HISTORIC LANDMARK COMMISSION  
STAFF REPORT

**Whittier Project**  
Legalization/Appeal PLNHLC2008-00578  
330 South 1200 East in the University Historic District  
November 5, 2008

The applicant requests that the Historic Landmark Commission legalize changes to a roof form that differ from an approval the Commission granted to a previous owner on August 1, 2001. On April 5, 2005, a request to legalize the work by the last owner of the property was considered by the Commission and denied.

**NORTH ELEVATION**  
SCALE 1/4"=1'-0"

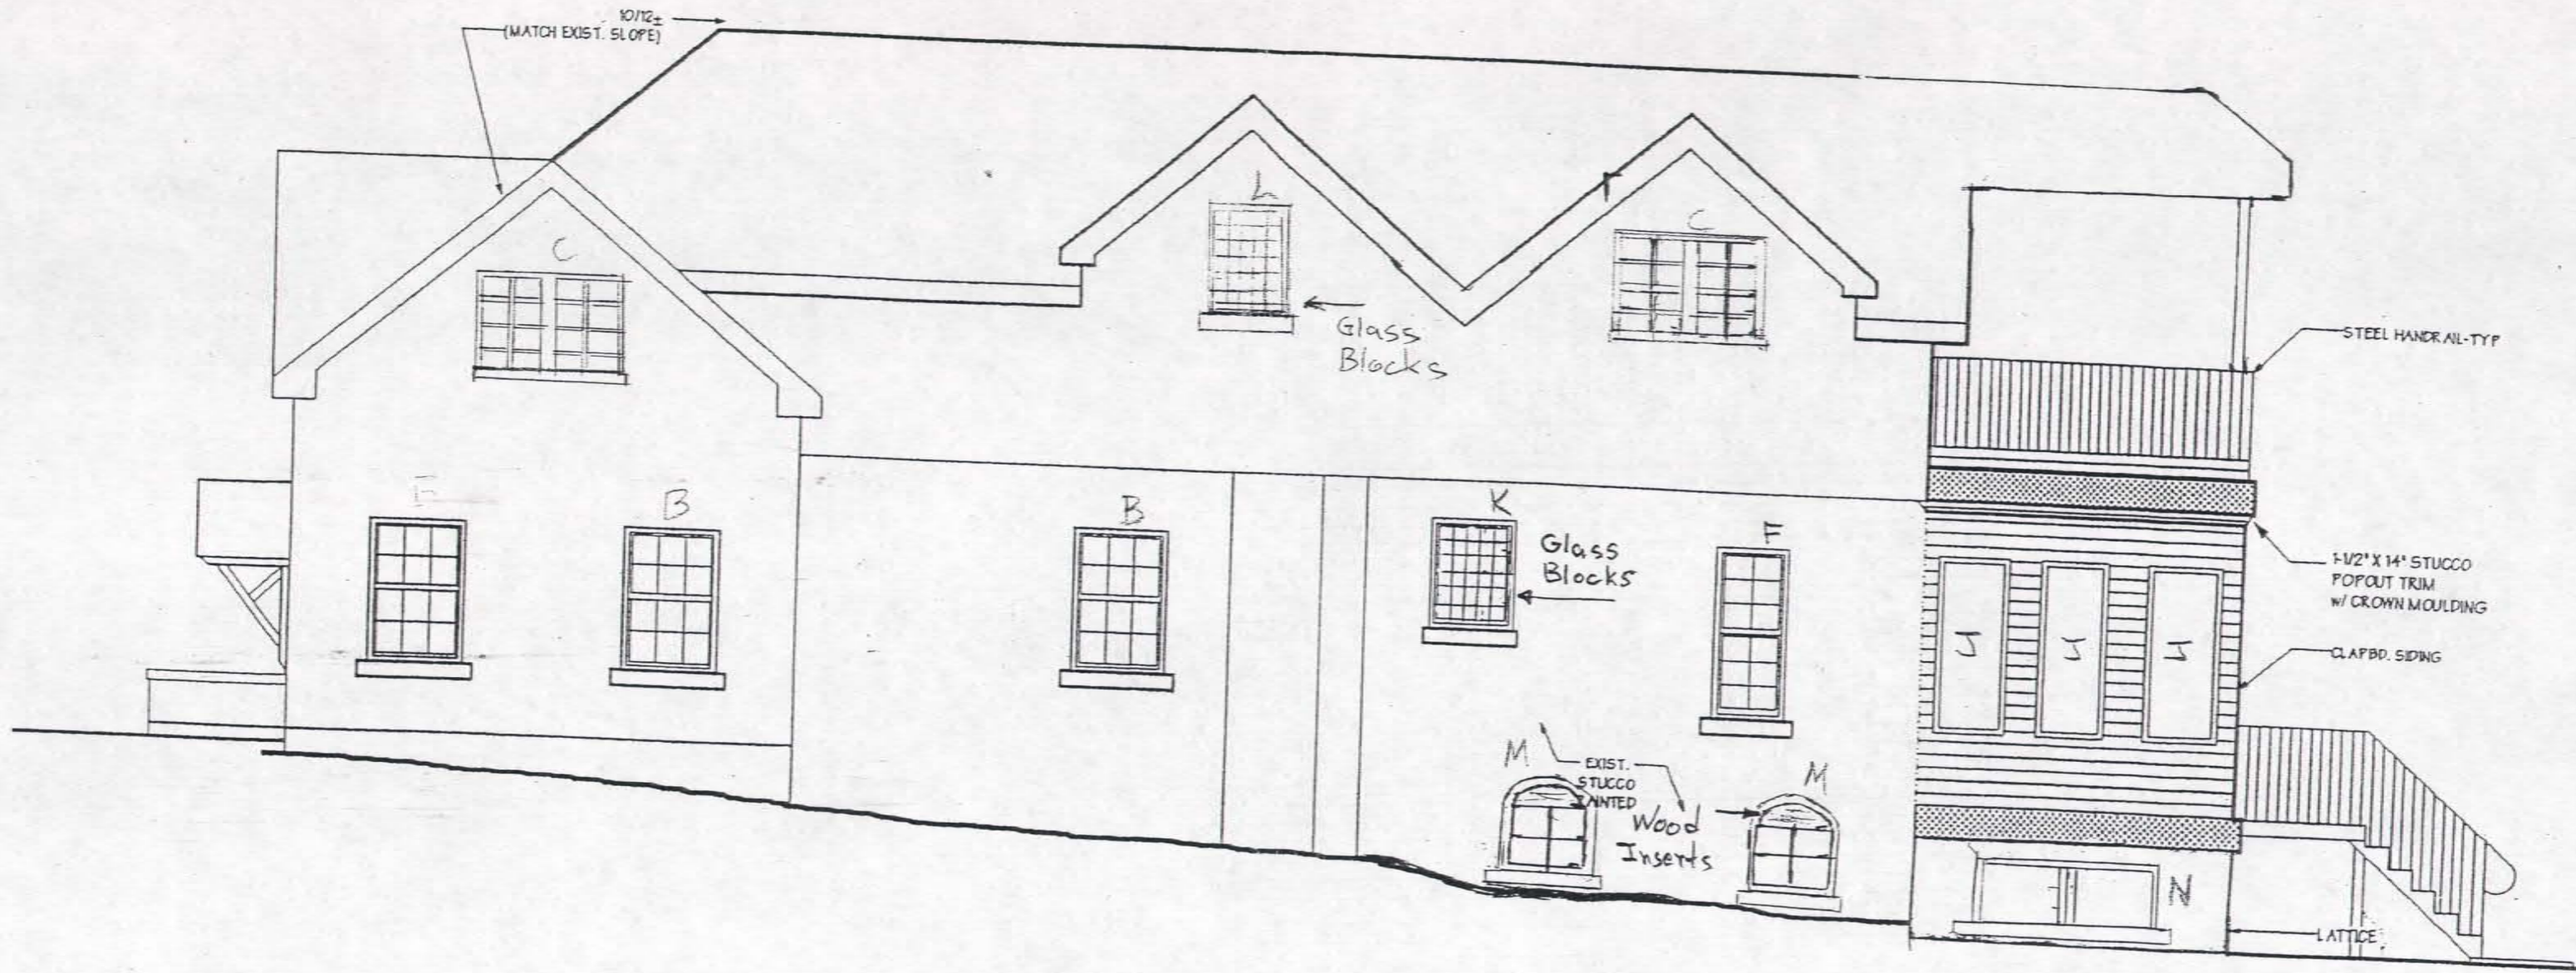
The applicant, for the most part, is attempting to replace the unacceptable windows with those that match the original, with the exception of the glass block for the bathroom areas on the north elevation. He is also willing to repair the damage that has been done to the historic integrity of the house by the prior owner's alterations to the size of the window openings themselves. He has provided a wall section indicating that the windows will be placed back into the wall, in order to provide the earlier visual relief between the wall surface and the window. The aluminum clad, Kolbe and Kolbe windows, with muntins no wider than 7/8," should be an adequate replacement window. Staff would entertain other window manufacturers if for some reason the Kolbe and Kolbe window are not acceptable to the applicant.

Mr. Parvaz inquired if the glass block windows were typical in historic buildings. He expressed concern because they did not exist in the original building. Mr. Parvaz believed the windows at that location were double-hung windows on the previous plan. Ms. Giraud said that glass block windows were not typical in historic buildings, but they would be on the side elevations toward the rear and not prominently seen. She added that glass block windows have been allowed previously. She thought the applicant would be open to other suggestions.

**Attachment D**  
**Photographs**

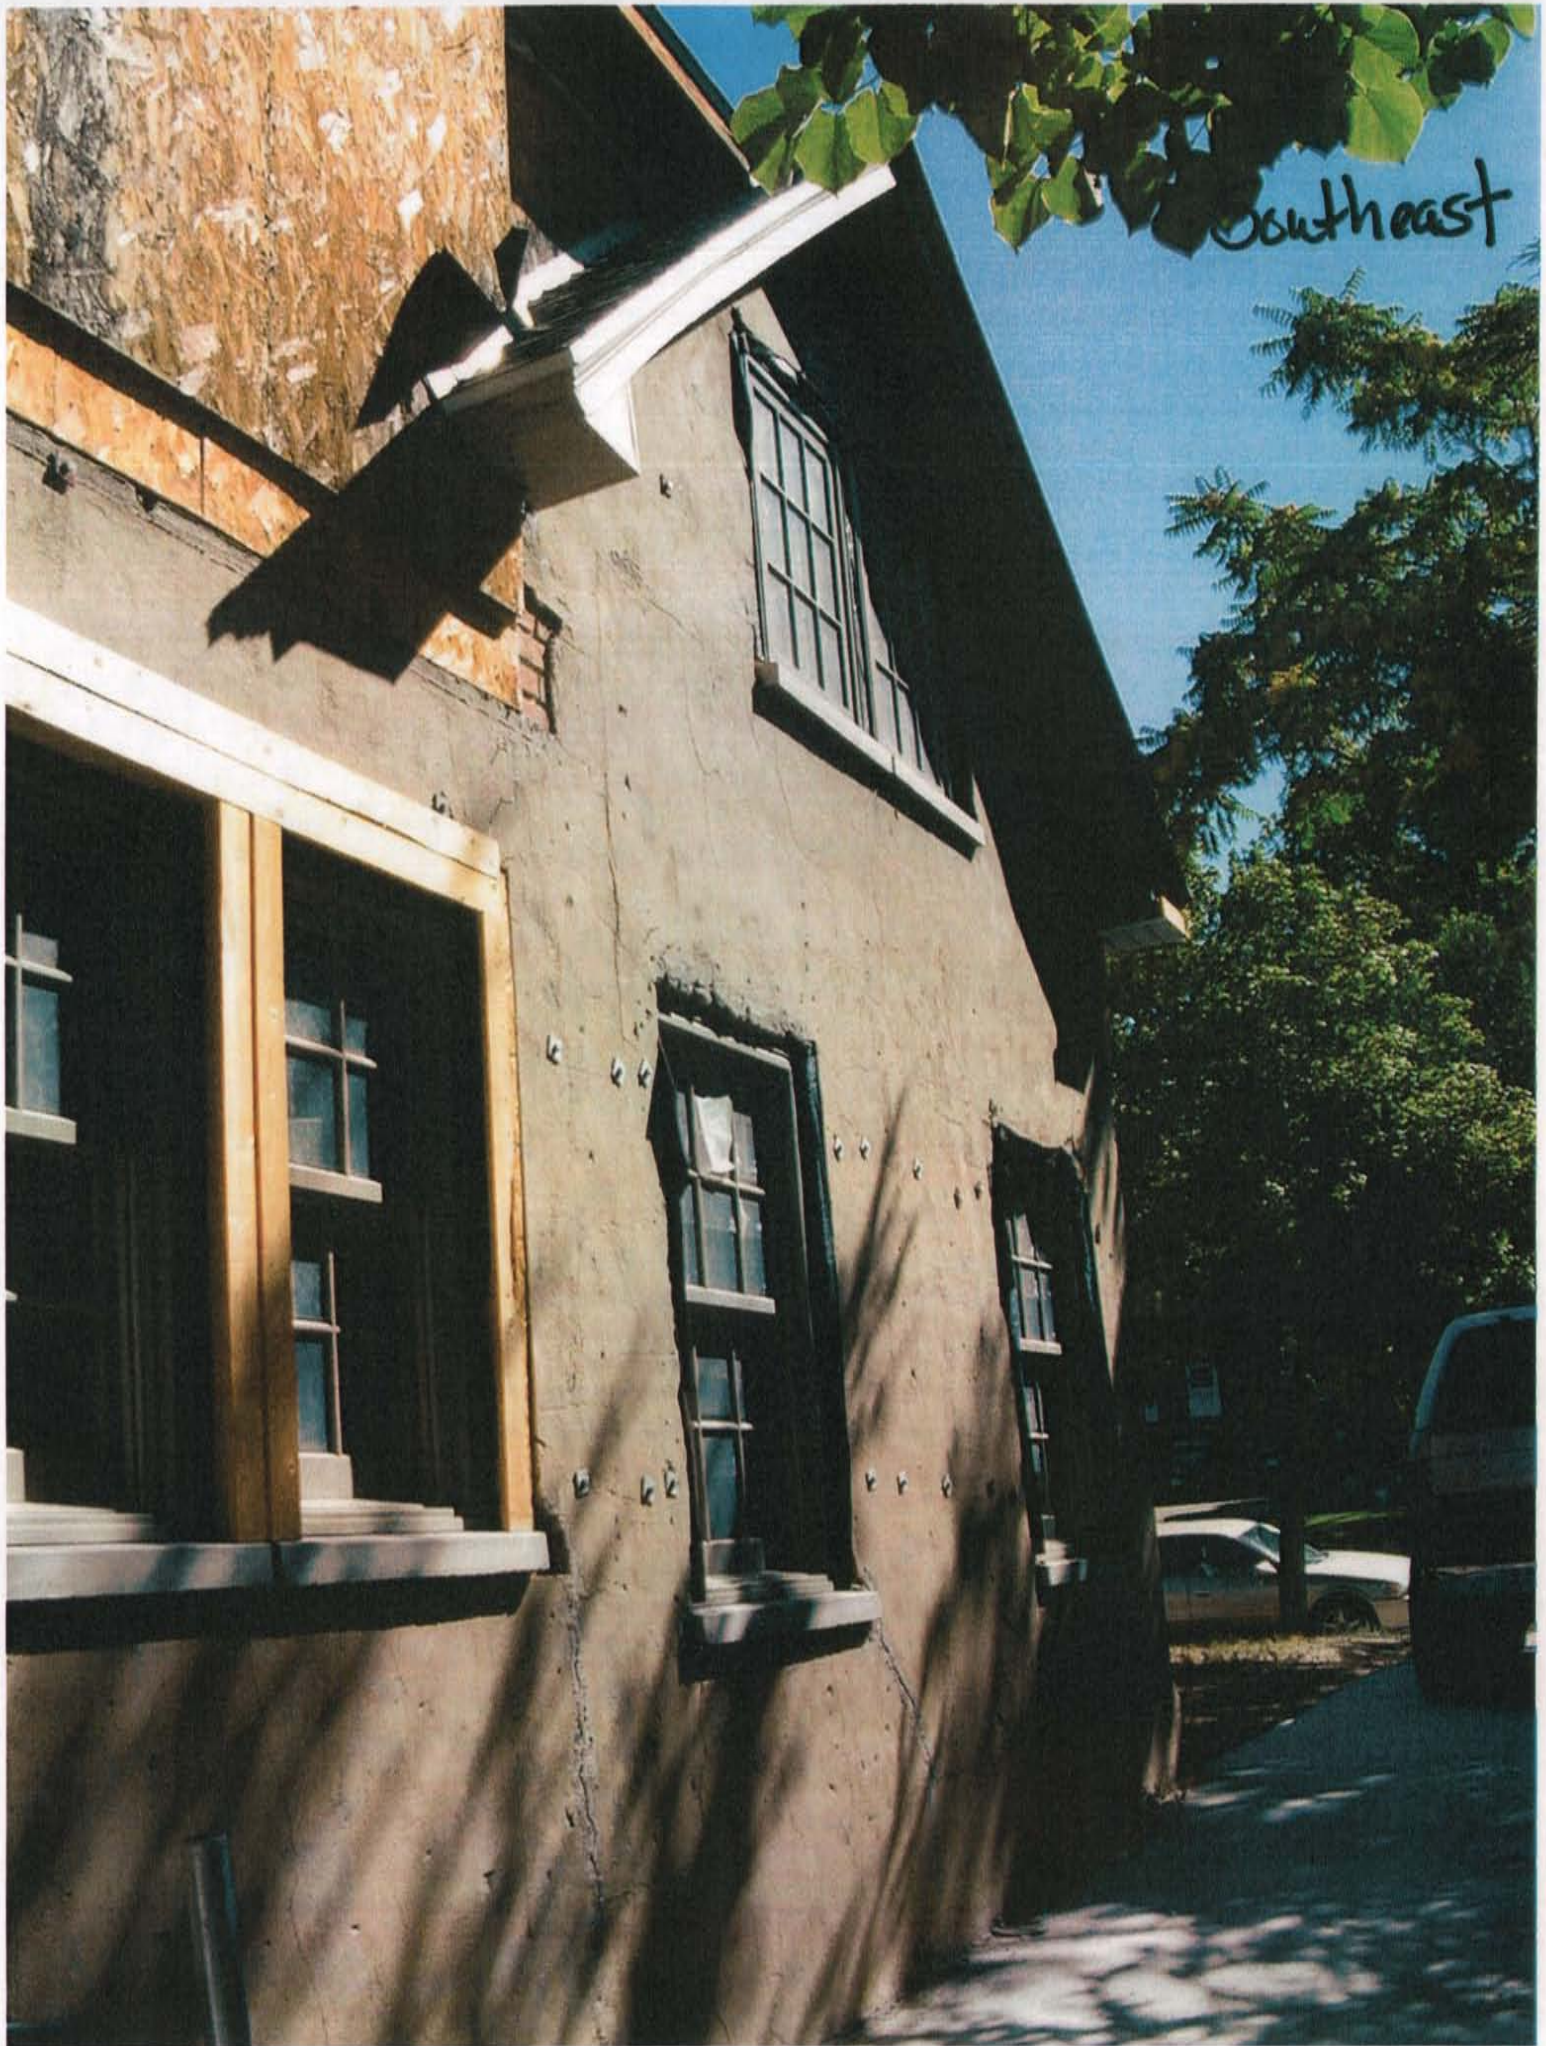
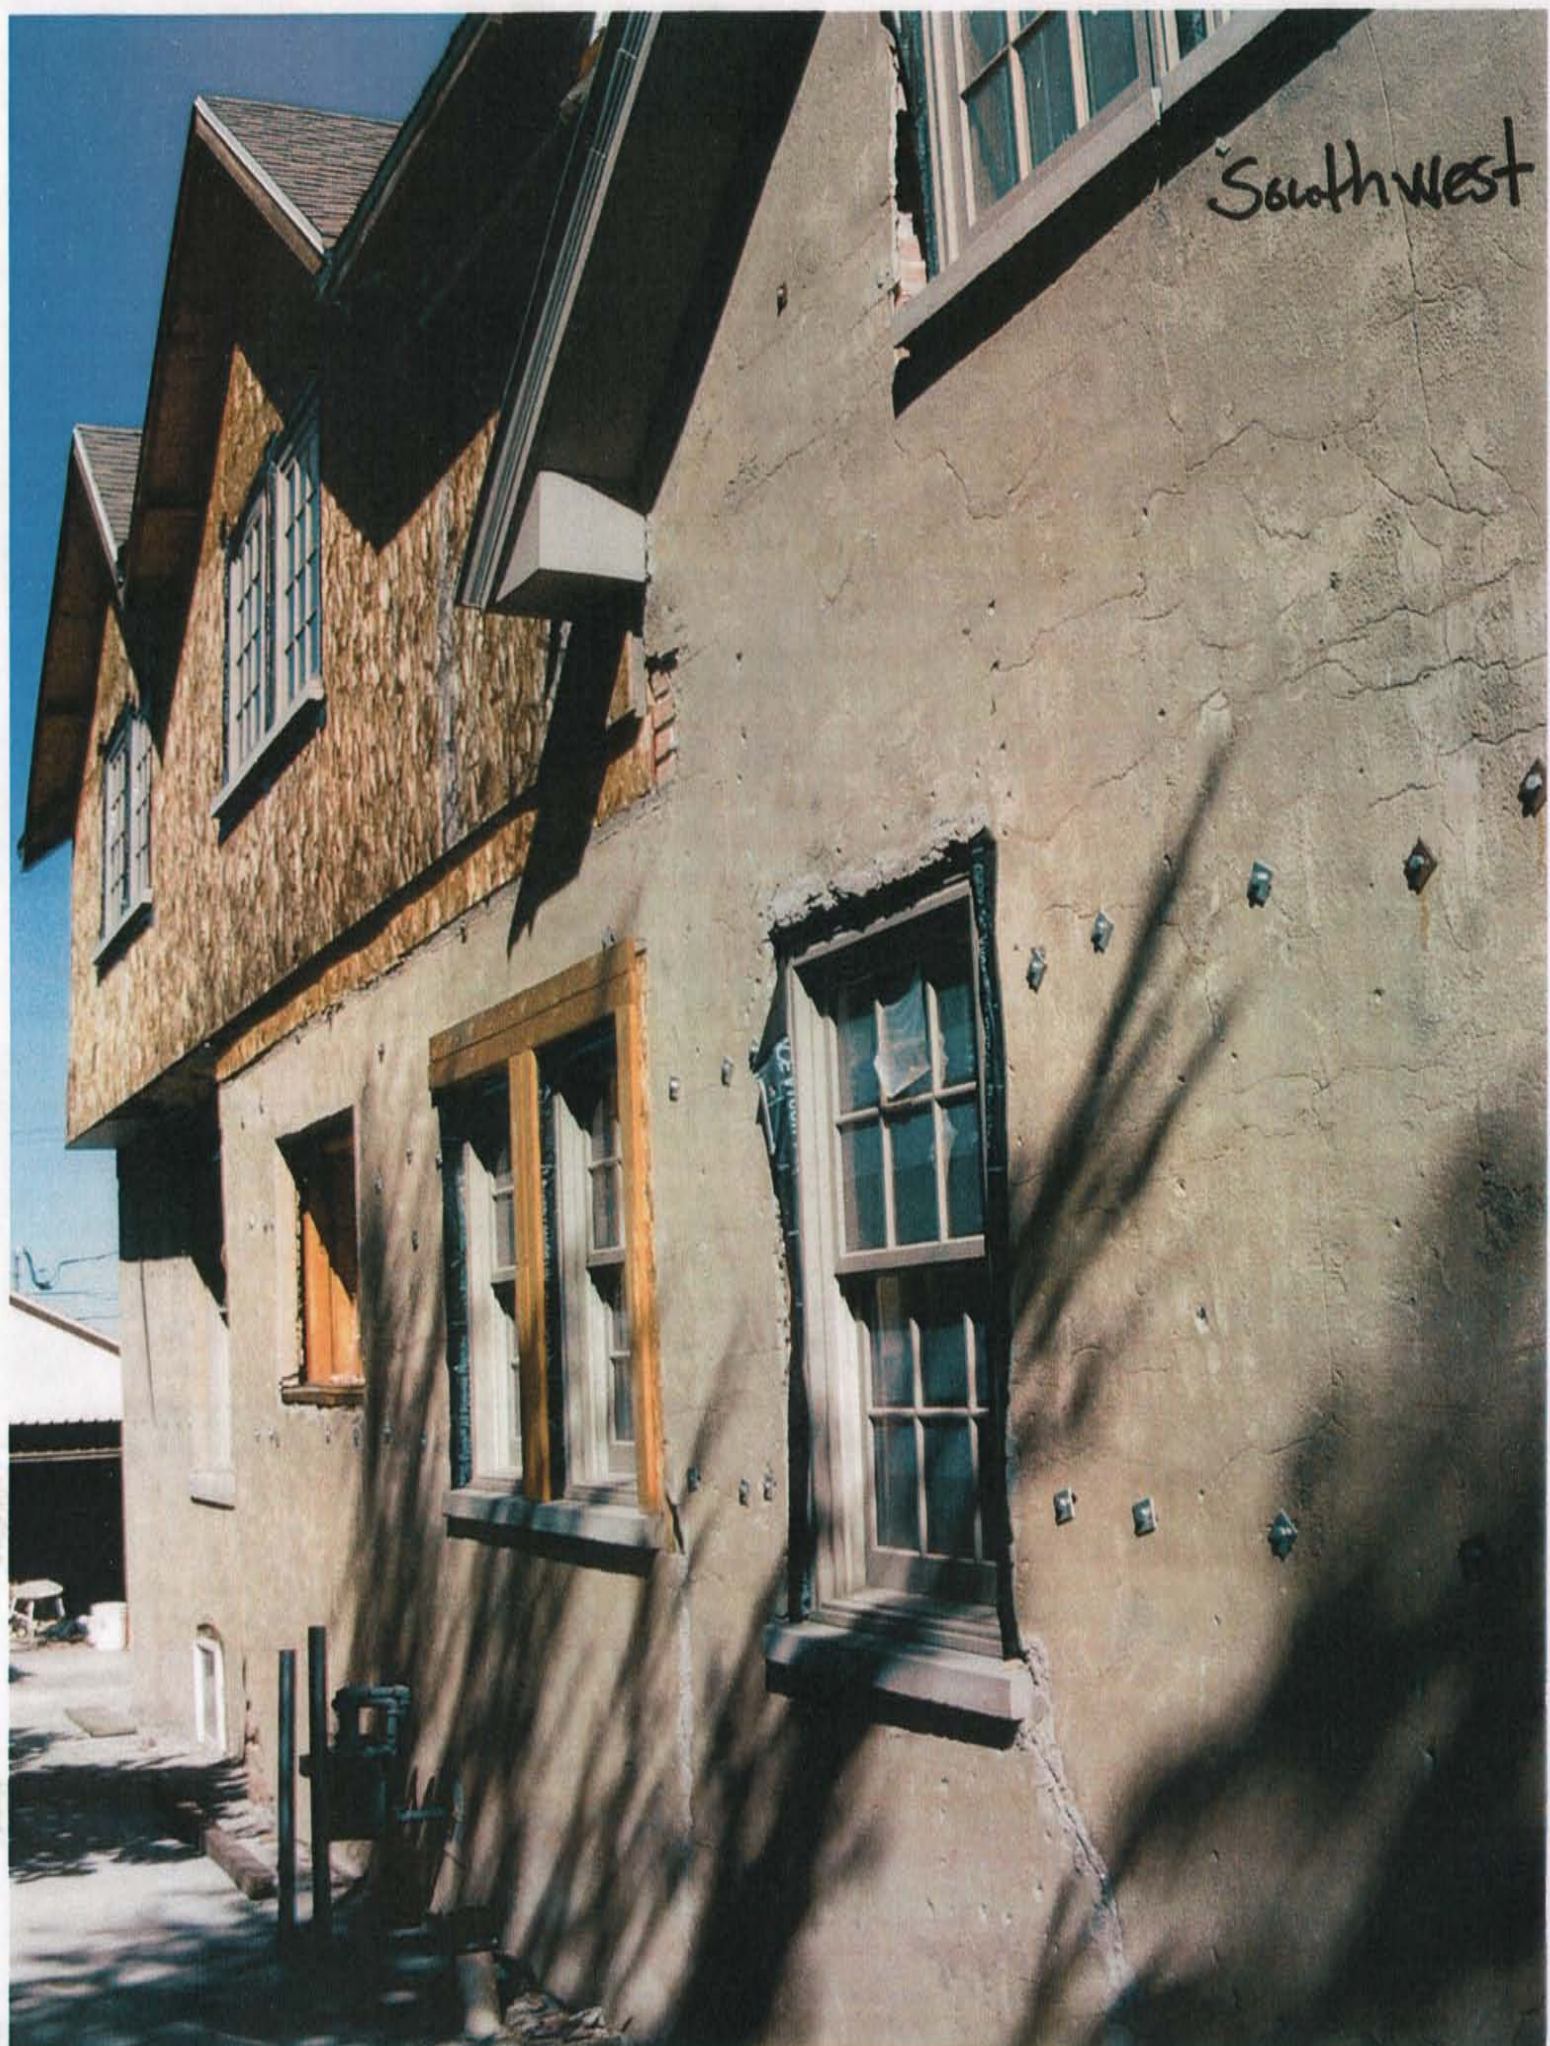
1. That the Commission denies the request to legalize the eastern part of the second-story roof as shown in the photographs attached to this staff report as Attachment A. The design fails to preserve the original roof form, a historically significant feature. Furthermore, the applicant must remove the portion of the roof that ties the side-gable of the original house to the upper story addition. Should the applicant present a roof design that respects the original roofline of the side gable and restores the connection as in the approved August 2001 plans (Case No. 017-01) attached to this staff report as Attachment C, staff requests that the Commission direct staff to issue a Certificate of Appropriateness for the work.
